# Amphenol Canada Corp - Product Change Notice (PCN)

PCN Date	January 10, 2020
Supplier Name:	Amphenol Canada Corp.
Amphenol Canada PCN Number	PCN-C1454
Description of Change	For harsh environment (rugged) USB Type C connectors starting with part numbers MUSBR-M1C1-xx (or -xxx) and MUSBR-M5C1-xx (or -xxxx), the packaging is changing from a full tray of 70 pieces per tray to a new tray with sub-divisions of 8 pieces per partition.
Reason for Change	Contact tails on these connectors are susceptible to damage if mis-handled. Customer or distributor splitting the quantity of parts with the large trays could result in handling damage. The new tray design will minimize the risk of damage resulting from handling.
Summary of changes between new and old part	Old packaging - 70 pieces per tray, 1050 pieces per full carton, outside carton dimension approximately 13.7 x 12 x 9" (350 x 305 x 230mm) L x W x D. New packaging - 32 pieces per tray, 384 pieces per box, 1152 pieces per full master carton, outside carton dimensions approximately 16.4 x 13.4 x 15.1" (415 x 340 x 385mm) L x W x D. Trays easily cut to 8 pieces per partition.

## OLD PACKAGING

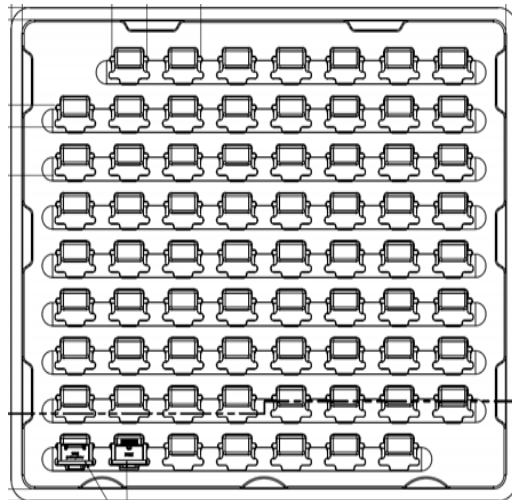
Cutting of trays to reduce quantities or packing parts in material other than the tray can lead to mis-handling damage.

Old tray with 70 pockets for connectors.  
Approximately 12.9 x 11.3"  
(330 x 285mm).

## NEW PACKAGING

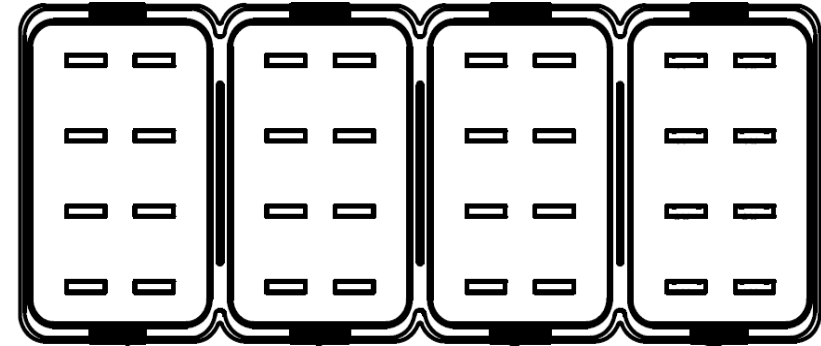
New tray for 32 connectors measures approximately 15.2 x 5.7" (385 x 145mm)  
The top and bottom edges of each partition is secured. The tray can be cut between partitions to reduce the quantity to 8 pieces.  
Customers or distributors in need of additional empty trays should contact Amphenol.
